In the Matter of the Application of San Diego
Gas & Electric Company (U-902-E) for a
Certificate of Public Convenience and Necessity
For the Sunrise Powerlink Transmission Project

Application No. 06-08-010
Exhibit No.: _____

CHAPTER 4
GREENHOUSE GAS EMISSIONS

March 12, 2008
Updated on April 15, 2008

Figure 1. Comparison of Sunrise Transmission Line Construction Emissions with the Operational Emissions Associated with Natural Gas Power Plants for a 40-year Analysis Period

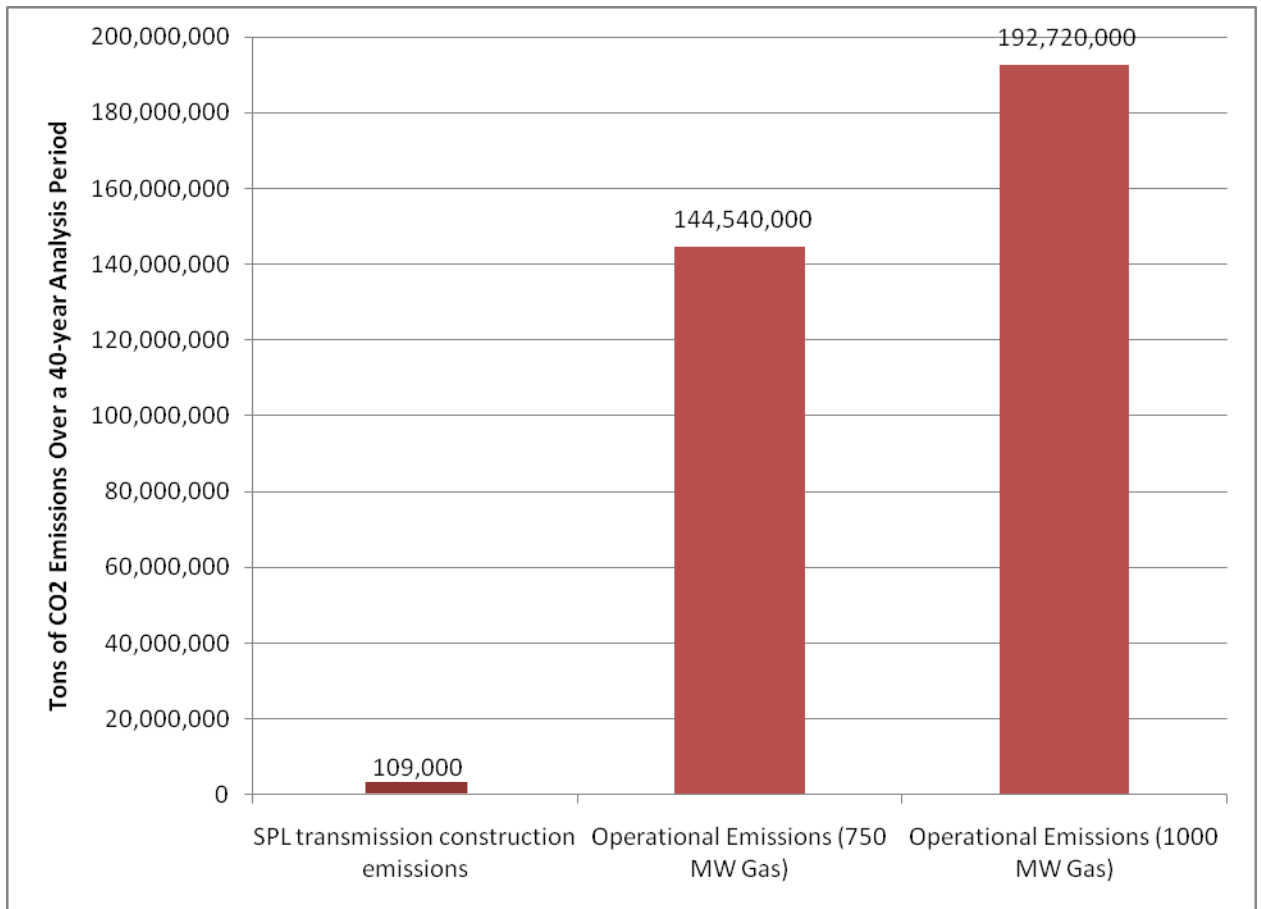
The CO₂ emissions generated from natural gas power plants delivering an average load of 750MW while meeting the Commission's GHG performance standard are approximately 7,227,000,000 lbs CO₂/year ($1100 \times 750 \times 24 \times 365$). This is approximately equal to 3,600,000 tons CO₂/year or 3.25 million metric tons ("MMT") of CO₂/year and is approximately equivalent to 1% of California's statewide emissions based on the March 2006 Climate Action Team Report.

In the DEIR, 40 years is the typical period used for many calculations regarding Sunrise based on an assumed 40 year operations period. Using this same event horizon, a 750MW natural gas power plant would emit approximately 130 MMT of CO₂ over a 40 year period. In comparison, the construction emissions for the Sunrise transmission lines are estimated in Section D.11.13.3 to be approximately 109,000 tons of CO₂ or 0.1 MMT emitted over two years. The comparison of transmission line construction emissions with the operational emissions of 750 MW and 1000 MW of energy delivered by natural gas are shown here as Figure 1. Based on this analysis, the operational emissions from a natural gas power plant with an average load of 750 MW are approximately 1,325 times greater than the construction emissions associated with the construction of Sunrise.

Based on the analysis above, 750 MW of energy generated from natural gas power plants would emit the total construction GHG emissions associated with Sunrise (109,000 tons CO₂) in approximately **11 days** time. The net result of this analysis is that construction GHG emissions associated with Sunrise are trivial compared to the operation emissions associated with even the cleanest fossil fuel power plants. In effect, the construction GHG emissions associated with the creation of transmission line access to renewable power will immediately be offset by the
